Westwood Developments' proposed new building on 68 Main Street Greytown Resource Consent Application Comment

Westwood Developments' proposed new building on 68 Main Street Greytown, the Greytown Little Theatre site and its Resource Consent Application to the South Wairarapa District Council dated 20 September 2018

Greytown Heritage Trust's ("the Trust") comment on the heritage aspects of the above proposal:

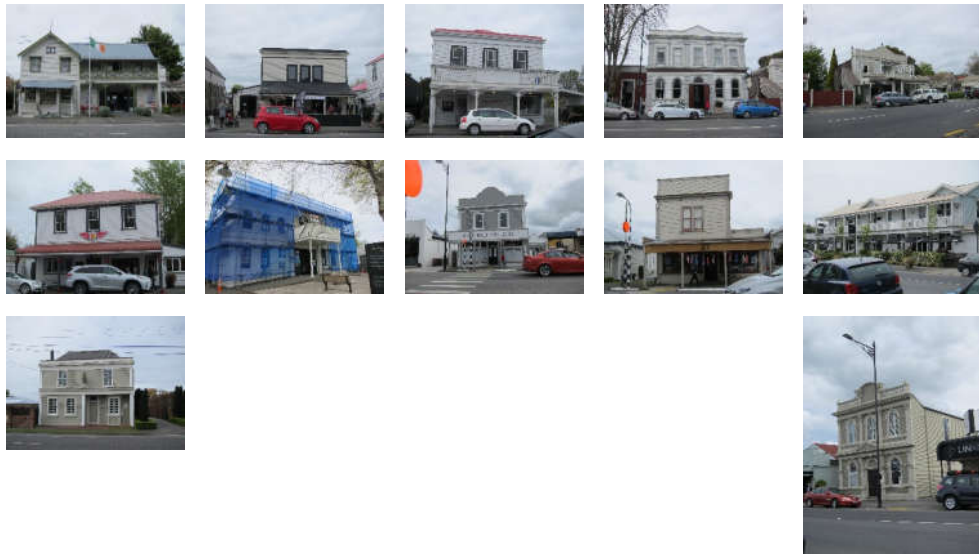
- g. Analysis of how the driveway works for the servicing (e.g. gas bottles, deliveries, maintenance, etc) of the building (concerns around width, height, items such as downpipes). How the loading bay is accessed; how the two-way ROW works safely (including pedestrians use the ROW to get to the Store on Lot 2 DP 52787);
- h. Assessment of the foundations required, and risks associated with these, particularly at the Wakefield Antiques boundary and any vibration.
- i. Assessment of how the building will be built and maintained (with it being built on the boundary with Lot 1 DP 81599).
- j. Indication of how the proposal maintains the Right of Way for Lot 2 DP 52787, with regard to the first-floor balcony protrusions;
- k. An Archaeological Authority;
- l. Describe what is being proposed regarding a plaque for the building as proposed in the Architecture Diagnostics report;
